Town Planner's Review
Wednesday, May 12, 2021

- XI. **Public Hearing - 19-21 Main Street – Parking Lot.** Formal application for site plan and conditional use for parking lot on four lots and reconfiguration of the entrance. Toomerfs, LLC c/o Pete Murphy and Tim Murphy, owners. Mike Sievert, engineer. Robbi Woodburn, Landscape Architect. Map 5, Lots 1-9, 1-10, 1-15, and 1-16. Church Hill District.
- I recommend that the board review the revised design and continue the review and hearing to May 26.

Revised plan:

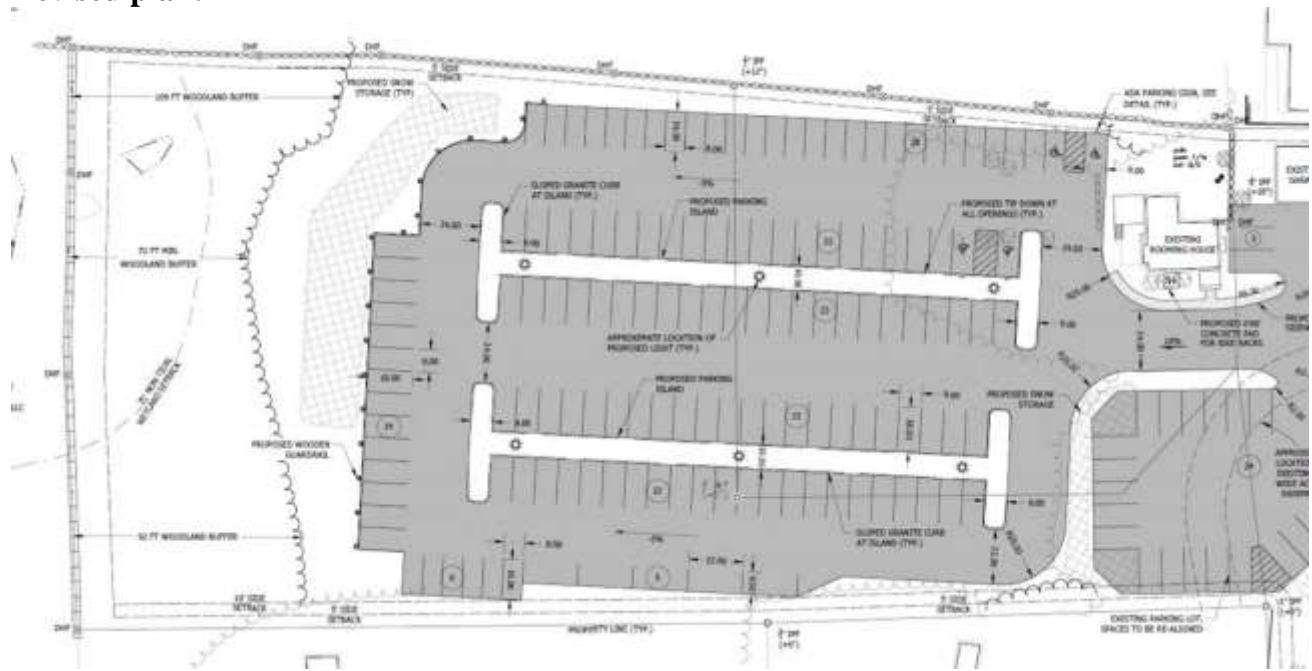
- The retaining wall is removed in entirety. The rear of the site will now be graded down at a 2-1 slope (2 feet of run to 1 foot of rise). The width of the two side buffers is not changed but they are regraded.
- The wooded buffer at the rear is reduced from 100 feet to between 72 and 109 feet.
- The total number of parking spaces is reduced from 180 to 169.
- The slope of the parking lot is increased from 2.9% to 5%
- There will be a wooden guardrail at the top at the rear
- Snow will now be stored off the rear of the parking lot.

The applicant will need to submit revised plans for stormwater and landscaping and any other elements that are affected. A rendering should be provided of the view toward the parking lot from the south showing the grading.

The board will need to determine if the revised rear buffer is sufficient in accordance with the conditional use criteria and Article 5. Landscaping and Screening Standards in the Site Plan Regulations, in particular Section 5.9 Screening.
